Service Bulletin

MTX60 Fuel Cap Inspection

Product Group: Rammers	Date Issued: 04/01/11	Service Bulletin No. RT20110401
Bulletin Type <input checked="" type="checkbox"/> Mandatory <input type="checkbox"/> Information Only <input type="checkbox"/> Recommended Change		Models/Series Affected: S/N V-6045 – V-6088, V-6093 – V-6098, V-6105 – V-6112, V-6129 – V-6132, V-6173 – V-6331

Figure 3. Cap with “Duck-Billed” Vent

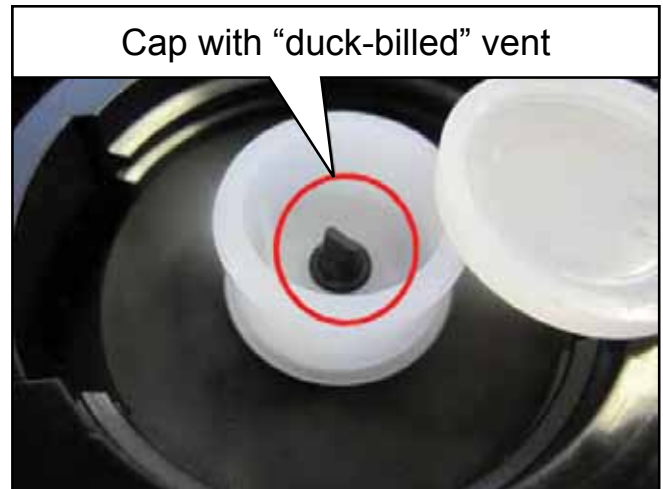
3. If the inside of the cap has a rubber “duck-bill” vent (Figure 3), no further action is required.
